CRASH INJURY EVALUATION

YHC-1B CHINOOK MOCKUP

YHC-1B U. S. ARMY "CHINOOK" MOCKUP EVALUATION
Morton, Pennsylvania
27 January 1960

REPORT OF CRASH INJURY EVALUATION
AvCIR-13-PV-118
September 1960

Figure 10. Aft landing gear (1); pressure fuel line (2).

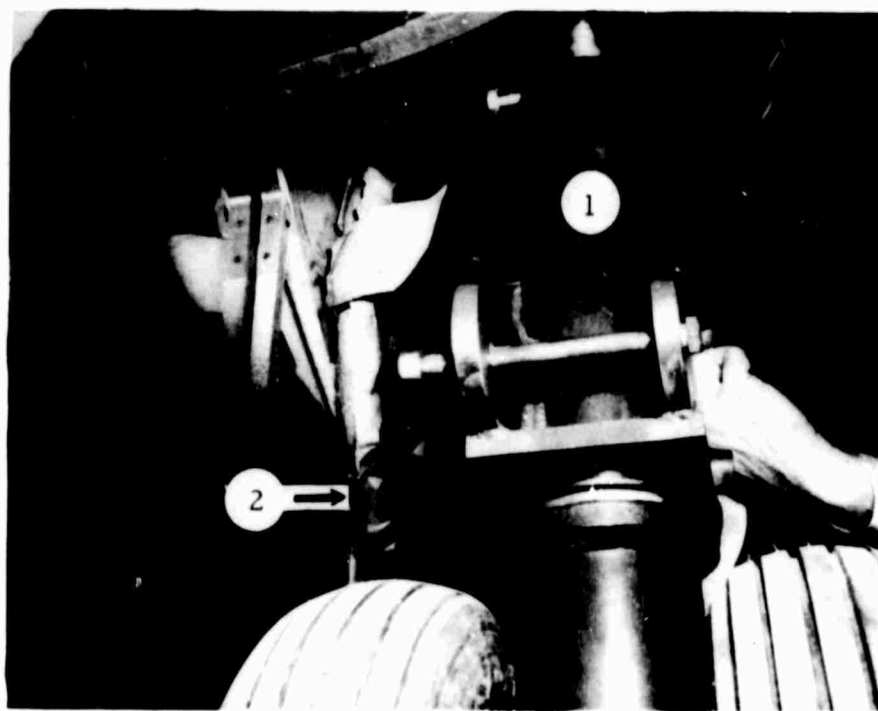
Note in Figure 10 that the pressure fuel line passes between the fuselage wall and the rear landing gear as it enters the fuselage with very little clearance. Any inward displacement of the aft landing gear during a hard landing or during a crash can easily rupture this fuel line. The line should be routed away from the aft landing gear to eliminate a potential source of fuel line rupture and subsequent post-crash fire.

Figure 15. Copilot's seat. Forward edge of seat pan (1) padded with firm density foam rubber; foam rubber seat pan padding (2).

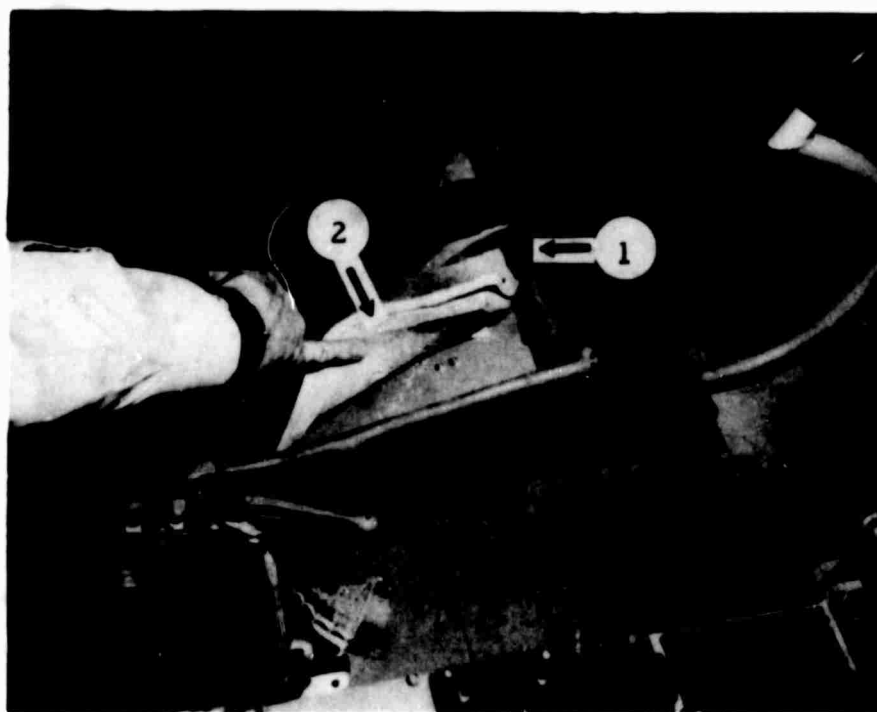
Arrow number 1 in Figure 15 shows the rolled, forward edge of the seat pan. Although padded with a firm density foam rubber, it presents an area for concentration of force to the underside of the thighs during vertical decelerations. This portion of the seat pan should be modified to provide a greater distribution of such forces to a larger area of the thighs.

1. The forward edge of the pilot and copilot seat pans be modified to provide for greater distribution (lower p. s. i.) of impact forces over a larger area of the thighs.

Figure 16. Pilot's seat, showing nylon seat cushion material (1); open snap fasteners (2); and seat belt anchorage (3).

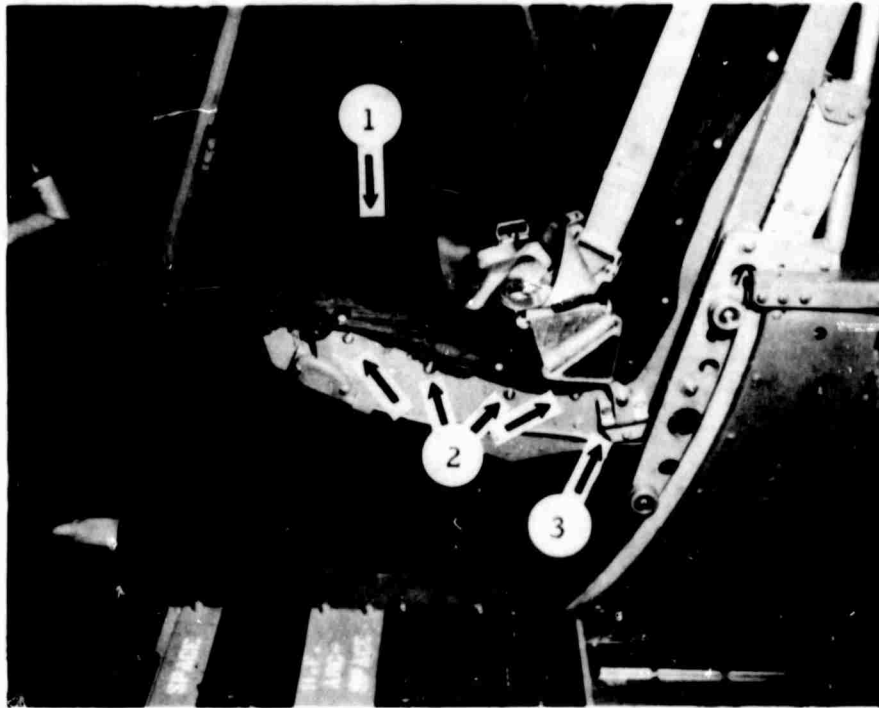
The nylon net material is fastened to the seat frame (Figure 16). During a crash, all snaps must be fastened to assure symmetrical loading of the seat pan material. Continuous maintenance will be required to insure that all snap fasteners are secured during flight.

Figure 17. Pilot's seat, underside. Seat track (1).

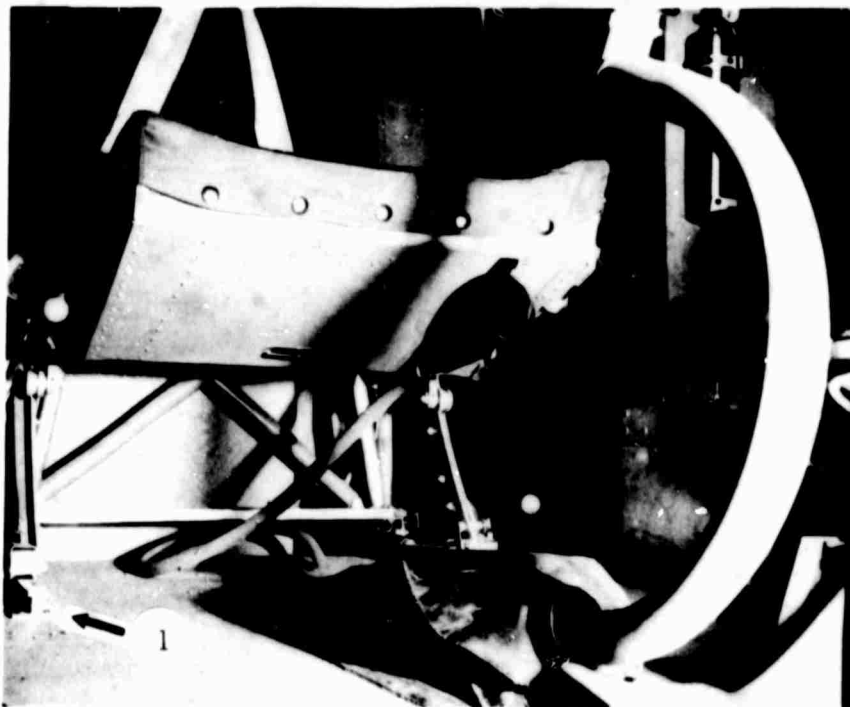
The seats are mounted on seat tracks, as indicated in Figure 17. Examination of the seat tracks revealed no forward stop. It appears that the seats can slide completely off the track in the event of jamming or failure of the manual control stops. Positive stops at the forward end of the tracks should be provided.

Figure 18. Copilot's seat tilt adjustment control (1); vertical adjustment control (2); tilt adjustment roller and track (3); safety belt anchorage (4).

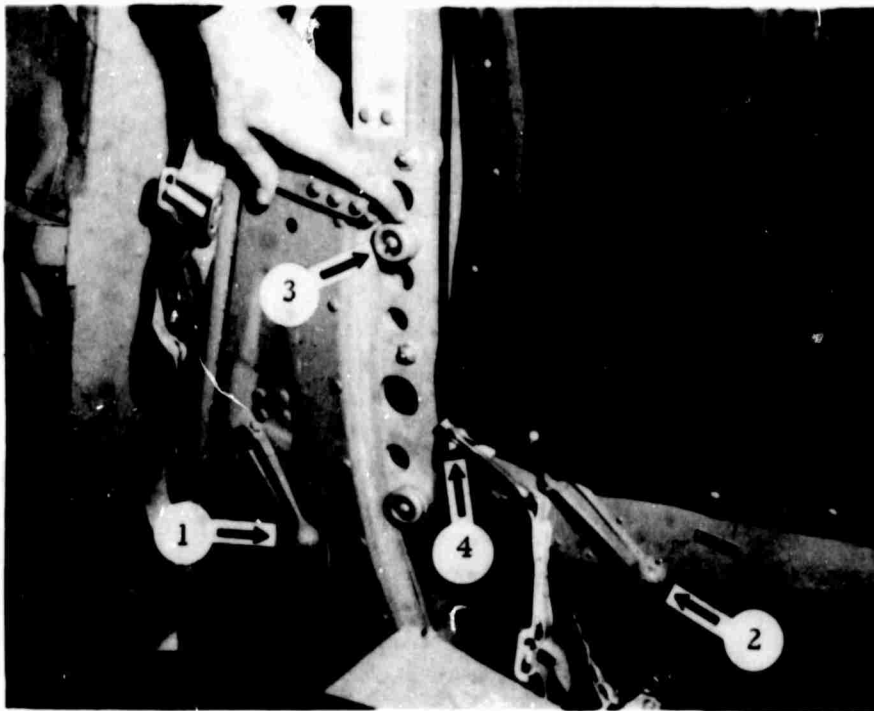
Figures 18 and 19 illustrate the mechanism for raising, lowering, and tilting the seat. This exposed mechanism is capable of inflicting serious injuries to anyone placing his hand on it while the seat is being adjusted. This mechanism should be covered with a safety shield to prevent contact during seat adjustment.

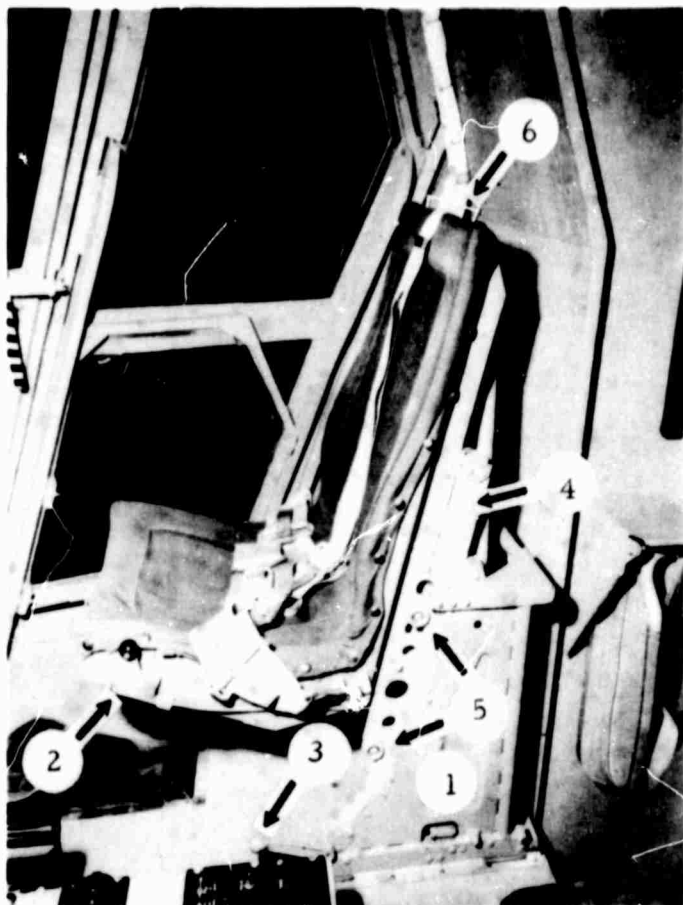
Figure 19 shows also the safety belt and shoulder harness installation. The seat belt anchorage is located at the lower left corner of the seat pan. The anchorage allows the belt to move inward or outward against the side of the seat pan and to rotate fore and aft in an arc. This form of self-alignment is a desirable feature, preventing anchorage failure due to prying action under side-load conditions.

The shoulder harnesses are attached to inertia reels mounted on the seat backs. Such an arrangement results in impact loading being added to the seat, which tends to overload the seat and cause failure of the seat supporting structure. If the seat does fail, the occupant

restraint system (seat belt and shoulder harness) becomes ineffective and permits the occupant (restrained in his seat) to be thrown in the direction of the crash force. This has been the cause of dangerous and fatal injuries in a number of helicopter accidents. Based upon the foregoing, the inertia reels should be attached to basic aircraft structure to prevent overloading of the seat during crash force decelerations and to provide occupant restraint in event of seat failure.

Figure 20. Pilot in normal seated position restrained by safety belt and shoulder harness. Lower edge of instrument panel (1); extended shoulder harness (2).

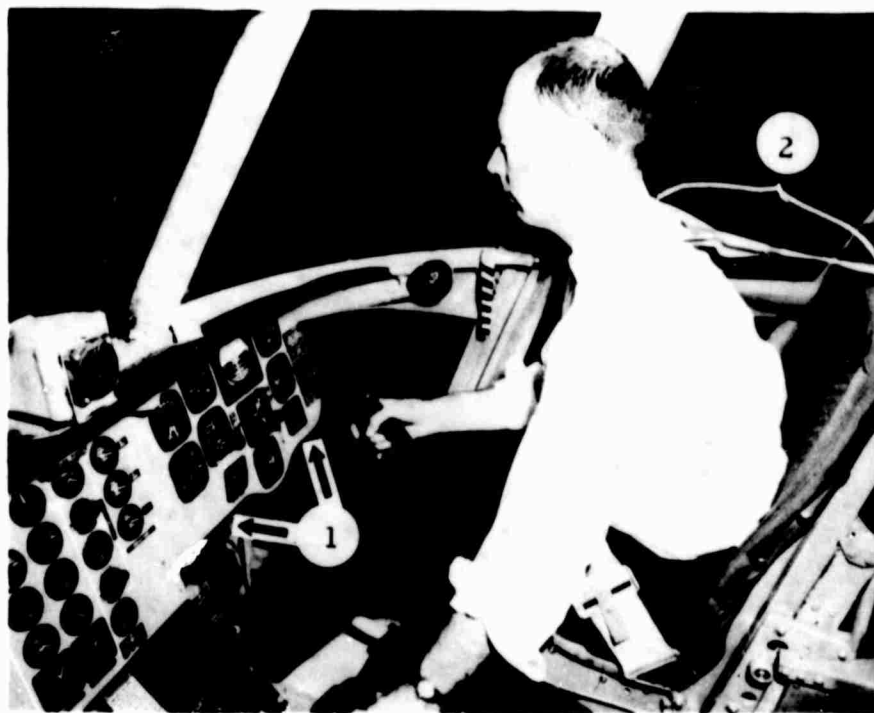
During the evaluation, it also was noted that the pilot was required to lean slightly forward in his seat in order to reach the controls comfortably, as illustrated in Figure 20. This position requires that the shoulder harness be extended over the seat back a distance of 15 to 18 inches. In the event the pilot (or copilot) is thrown sideways, the extension of the shoulder harness coupled with the unusually wide harness guide (shown in Figure 19) will permit him to strike the door frame and door jettison handle, as illustrated in Figures 21 and 22.

6. The location of flight controls (pitch and cyclic controls) be modified in such a manner that they can be manipulated from a normal upright seated position.

Figure 23. Pilot's head striking aft bulkhead.

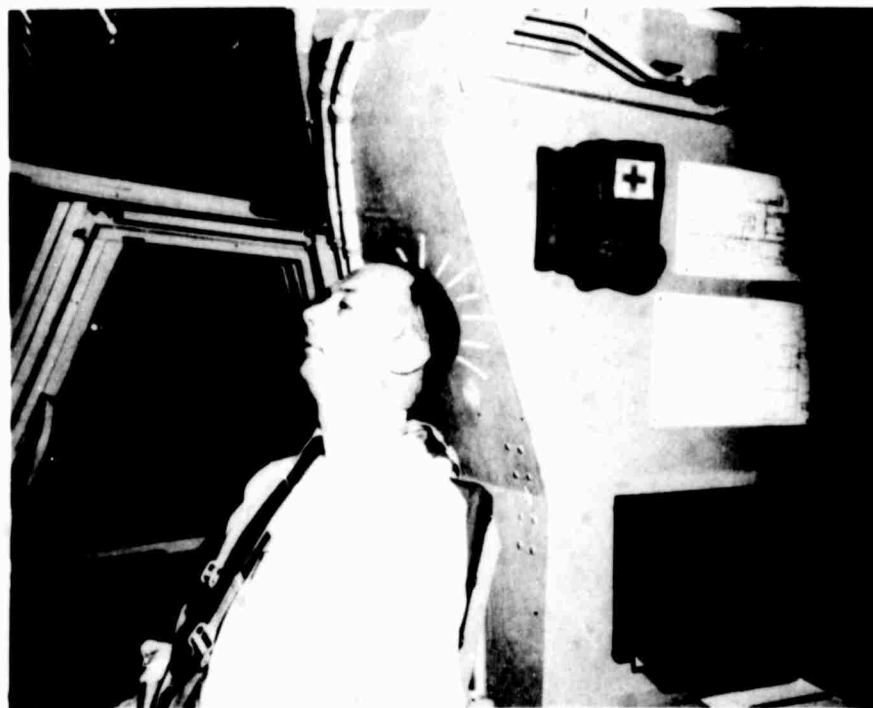
Figures 23 and 24 illustrate the manner in which both the pilot and copilot can be injured by striking their heads against the aft bulkhead by rebound during longitudinal decelerations. The bulkheads behind the pilot and copilot seats should be padded with high energy absorption material.

Figure 25. Instrument panel (1); glare shield (2); control pedestal (3); console (4); sharp edge lower instrument panel (5).

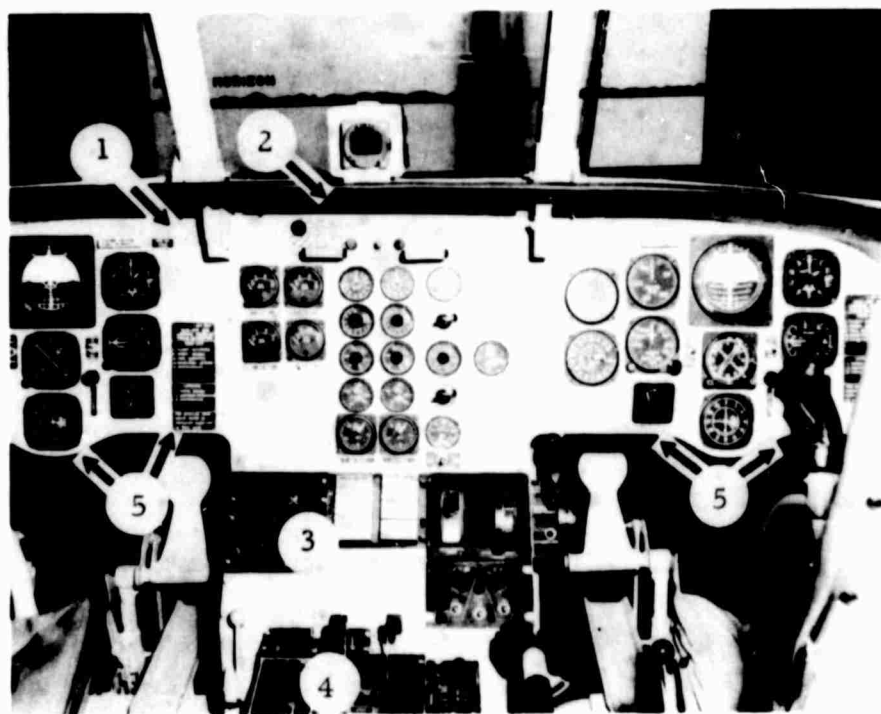
The instrument panel, shown in Figure 25, is mounted low and well forward of the pilot and copilot. The panel is beyond striking range of either of the occupants provided they are properly restrained; however, the lower edge of the instrument panel has a sharp edge which can inflict lower extremity injuries when the legs of the pilot and copilot flail upward during longitudinal decelerations. This lower edge should be padded or shielded to reduce possibility of injury.

Figure 27. Crew chief/troop commander seat in flight position (looking aft). Seat back (1); seat pan snap lock (2); forward hinge point (3); safety belt (4); map case (5).

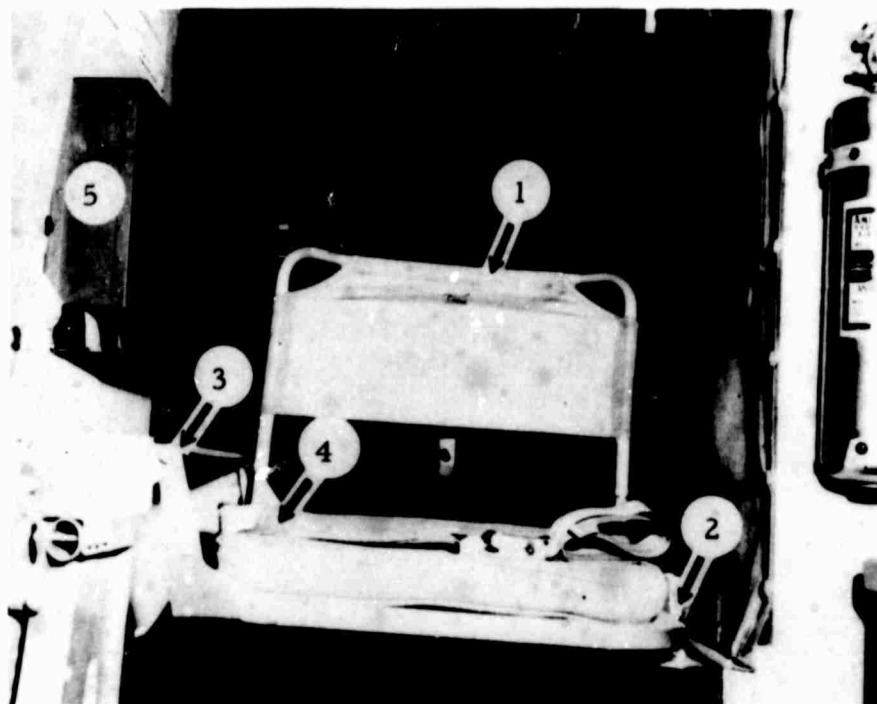
In the flight position (Figure 27) the occupant is restrained only by a seat belt. The lack of upper torso restraint will permit the occupant to be thrown against various items in his immediate environment during a crash, as illustrated in Figures 28, 29, and 30. The low seat back also could cause a serious back injury in the event this crew chief rebounded during a forward deceleration. This seating arrangement should be carefully studied and every effort made to provide the occupant protection at least equal to that of the pilot and copilot. A higher seat back, some sort of upper torso restraint, and padding of those surfaces within striking range of his head would provide such protection.

Figure 44. Safety belts (1 and 2).

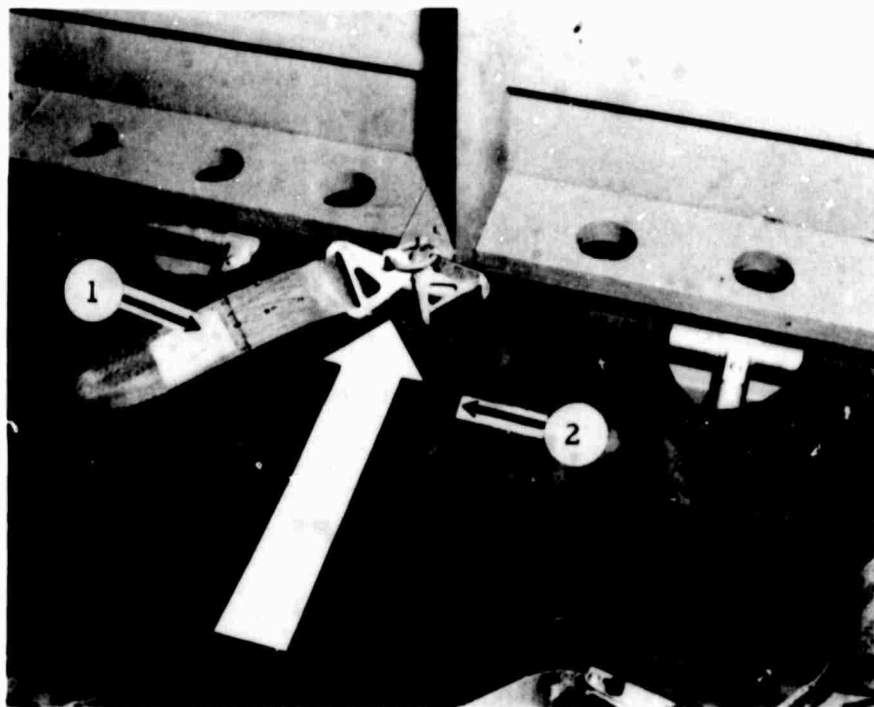
Attention is invited to the manner in which the seat belts are attached to the "O" rings. Securing portions of two seat belts to a single attachment point (Figure 44) frequently results in failure of the anchorage due to the overload applied by two occupants. The seat belts, attached at points above the level of the seat pan, ride across the abdomen of the occupants (Figure 46).

Figure 57. Closeup - Cargo door (1) in closed position; ramp (2); ramp extension (3); emergency exit (4); pull tab release (5); ramp extension hinge (6).

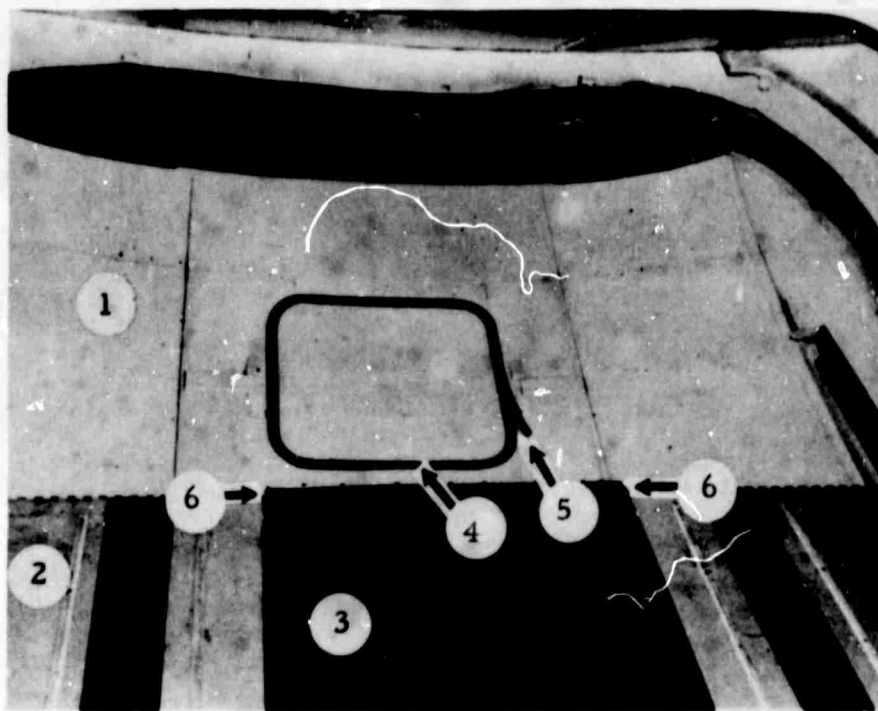
Note: Three ramp extensions will sometimes be utilized. There is no positive lock to prevent these extensions from swinging around to block the cargo door opening in the event the aircraft rolls onto its side.

Figure 58. Front left cabin emergency exit (opposite main cabin door). Nylon troop seat webbing (1); upper attachments (2); upper beam (3).

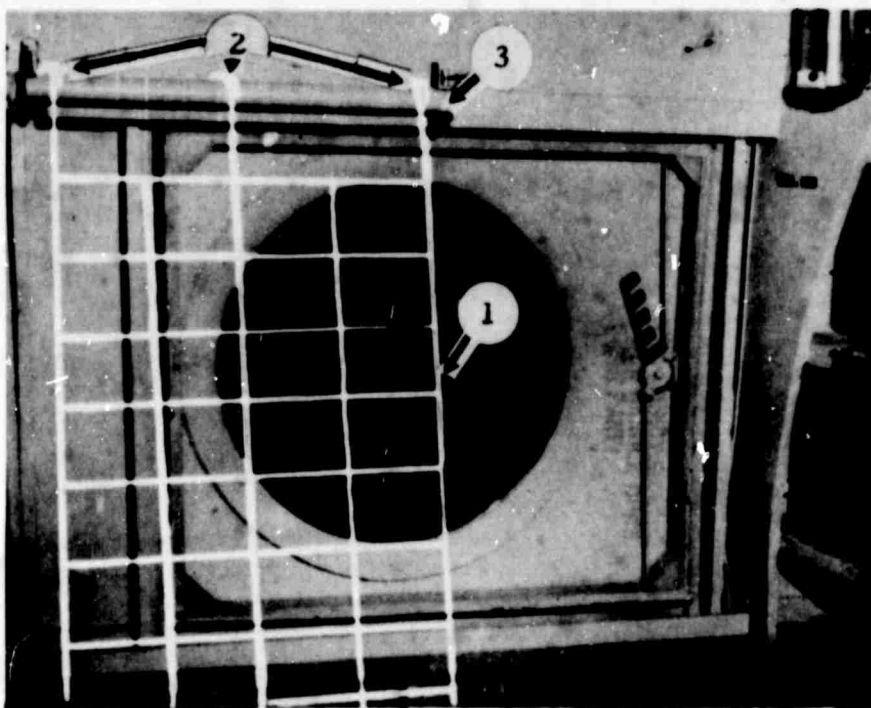
Figure 58 illustrates the position of a troop seat partially blocking the emergency exit opposite the main cabin door. The time required to remove the troop seat webbing before the exit can be used in an emergency will further delay the evacuation of the troops.

- b. Two additional window exits be added;
 - c. All other windows in the main cabin be designed so they can be kicked out in emergency conditions;
 - d. A quick disconnect for seat back webbing in front of the escape panel opposite the main cabin door be provided;

Figure 59. Top of cabin. Drive shaft tunnel (1); engines (2); aft pylon (3); possible area for overhead emergency exits (4).

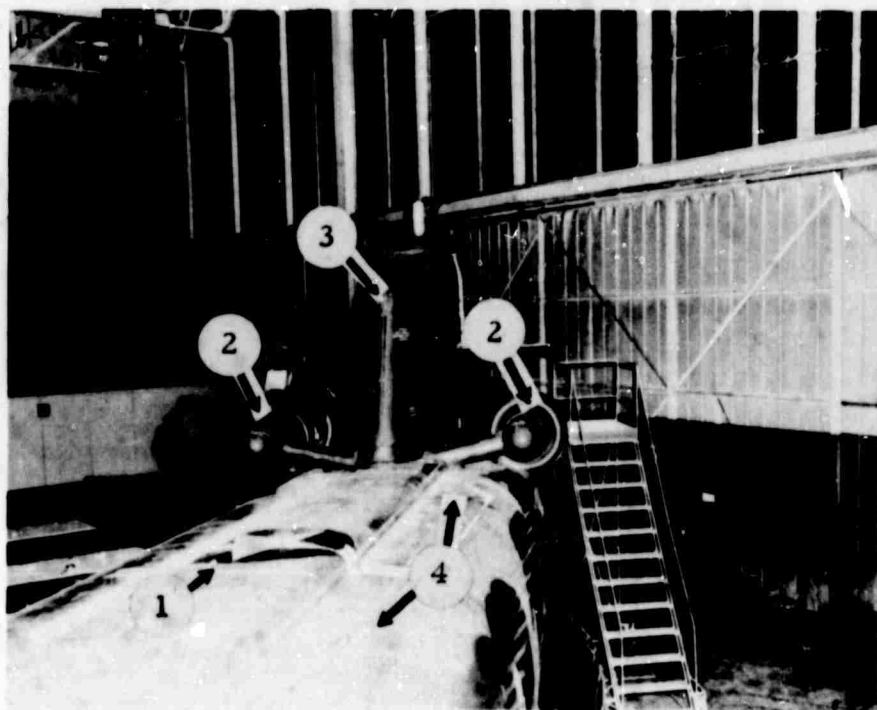
A review of the emergency exits provided in this aircraft reveals that there are only three normal exits available. The cargo door might possibly be used as an exit; however, it should be considered only as a supplement, since it is questionable whether the door can be readily opened after the crash, and there is always the possibility of this door being jammed during the accident. If open prior to the accident, there is also the possibility of its being blocked by such items as the ramp extensions (Figures 56 and 57). Another supplementary exit is the hoist/rescue hatch in the center of the cabin floor; however, the equipment installed in this hatch would require removal prior to use. It is questionable whether time would permit utilization of this hatch as an emergency exit.

- b. Two additional window exits be added;
